# CAA Environmental Assessment

## Temporary Airspace Change Proposals

Title of airspace change proposal	Solent Transport TDA
Change sponsor	SKYLIFT UAV Limited
Project reference	ACP-2022-106
Account Manager	[REDACTED]

**Figure 1 – the TDA structure (including the stub) overlaid on a satellite map.**

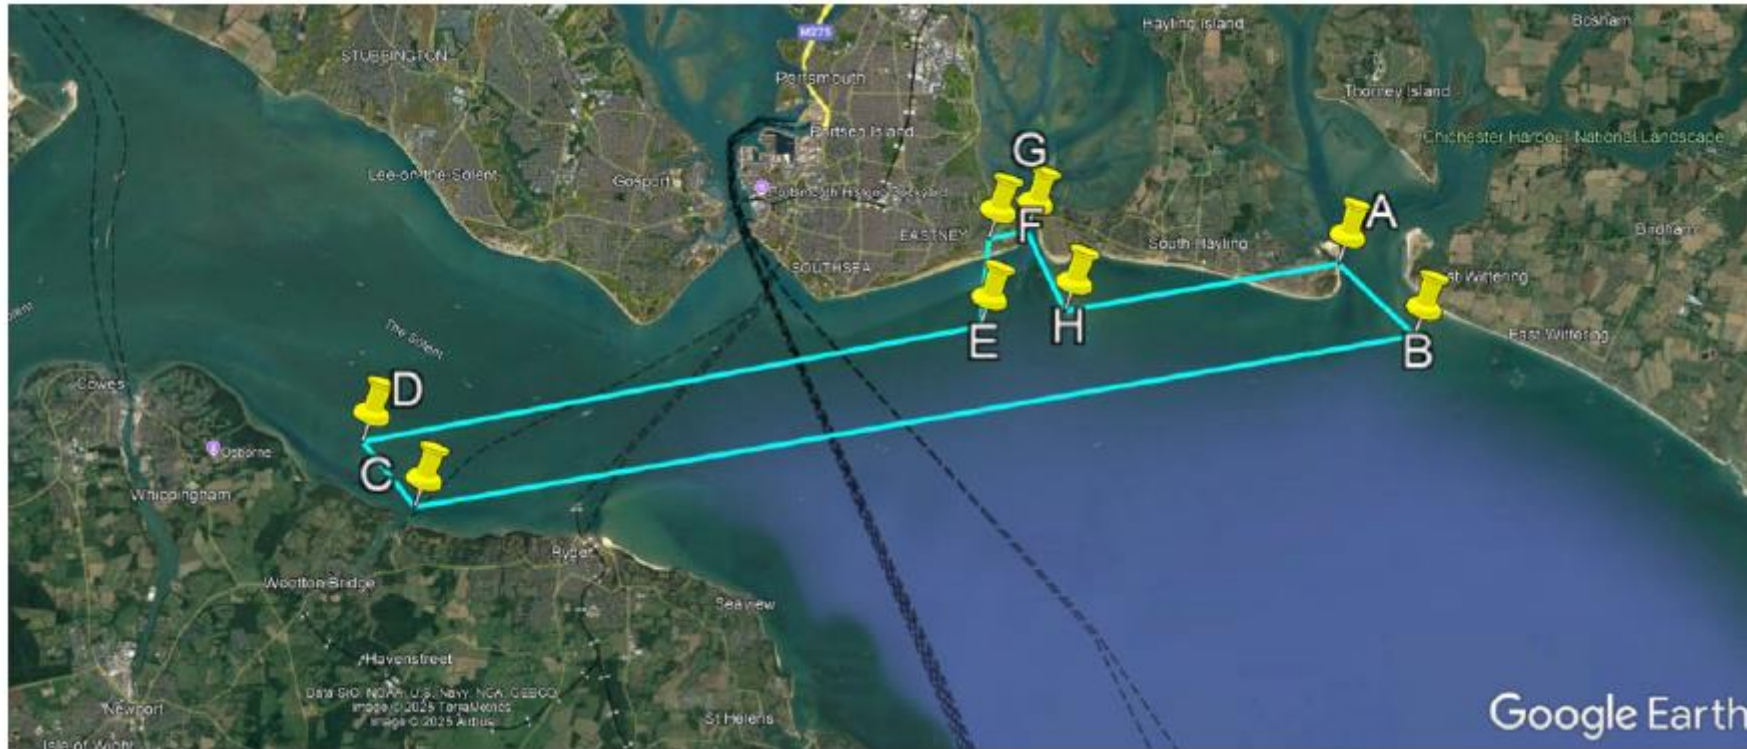
The final proposed TDA structure can be seen below in figure 1. The light blue lines reflect the lateral boundaries of the TDA structure. The stub to the north of the TDA (labelled with F, G, E and H) is intended to provide access to the TDA when the UAS is operating under Visual Line of Sight (VLOS), and it is within the stub that the aircraft operator will switch from VLOS to BVLOS. The stub contains the only take-off and landing site for the purpose of this trial. Vertically, the TDA structure will extend from the surface to 600ft AGL.

The lateral dimensions of the proposed TDA have changed significantly throughout the trial ACP submission process with the final TDA structure shown in Figure 1 representing a significant reduction in volume, particularly over land when compared to the TDA structure first engaged upon. The Stage 4 Submission document (v2) lists how and why changes to the final proposed TDA structure have occurred. This trial ACP has followed the process listed

**Figure 2 – Aircraft count by altitude range for August 2024, below 2,000ft AMSL**

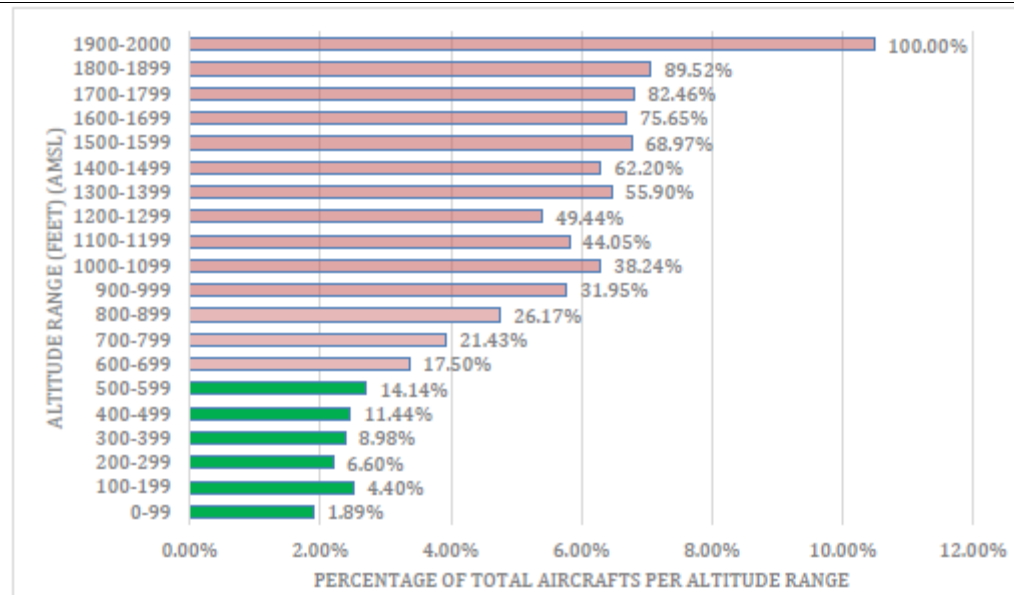
Further, the sponsor provides a traffic analysis survey undertaken for the month of August 2024 which is considered to be indicative of a busier summer month. Traffic at, or below, 599ft is shown in the below figure as green and this traffic makes up approx. 24% of all traffic detected in August 2024. The data presented shows that the majority of traffic recorded (86%) was operating at or above 600ft within the vicinity of the TDA and would not be affected by the proposed TDA and subsequent trial operations.
